## SERVICE BULLETIN

Reference number:	SB-01-1066	Issued: 05 March, 2018
Subject:	DB11 Door Trim Panel Noise	
Model(s):	DB11 Coupe	
VIN Range:	L03717 thru L04974. (But not L04668, L04907, L04946, L04955, L04965, L04967, L04970, L04971 & L04973)	
Applicable to:	All Dealers	
Distribute to:	After Sales Manager Executive Manager Service Manager Sales Manager	Warranty Staff Technician(s) Parts Staff

**Figure 3**

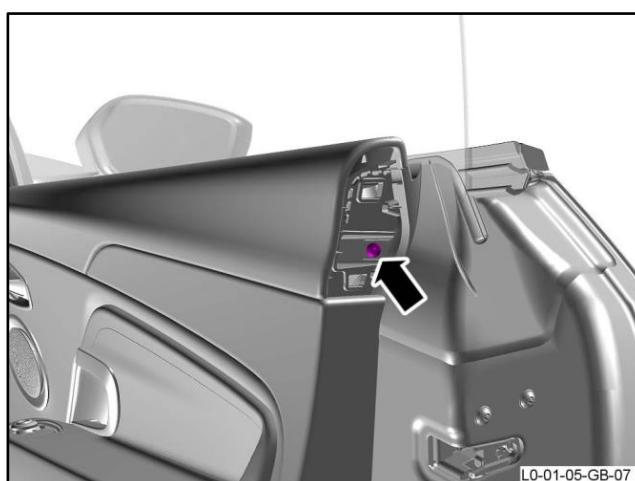
4. Remove the screw that attaches the trim panel to the door (refer to Figure 3).

**Figure 4**

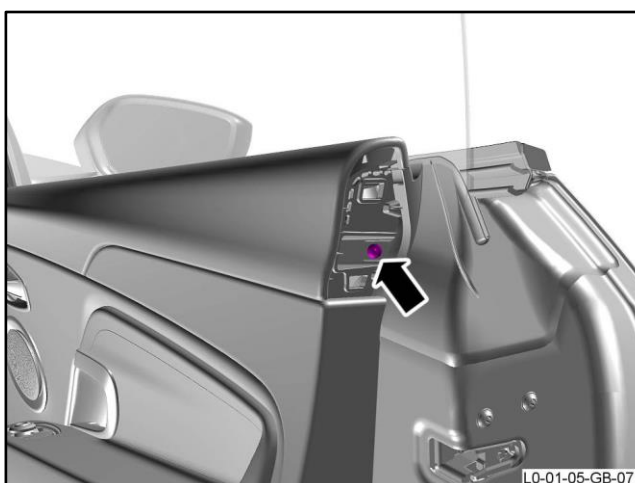
5. Replace the screw that attaches the trim panel to the door with part no. 700242 (refer to Figure 4). Tighten the screw to 5 Nm.
